Amendments to document TRANS/WP.29/GRSG/2001/10/Rev.1

(Transmitted by the expert from France)

Model A

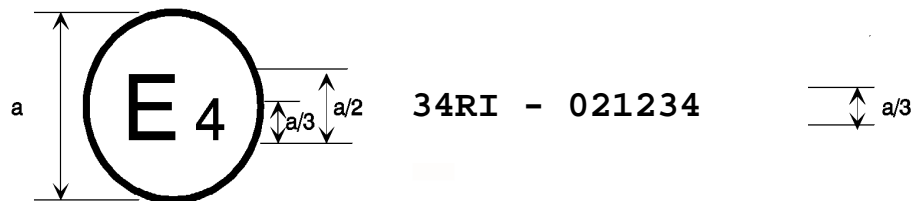
Annex 2, amend to read:

"Annex 2

ARRANGEMENTS OF APPROVAL MARKS

a = 8 mm min

The above approval mark affixed to a vehicle shows that the type concerned was approved in the Netherlands (E4) pursuant to Part I of Regulation No. 34 under approval No. 021234. The first two digits (02) of the approval number indicate that the approval was granted in accordance with the requirements of Regulation No. 34 as amended by the 02 series of amendments.
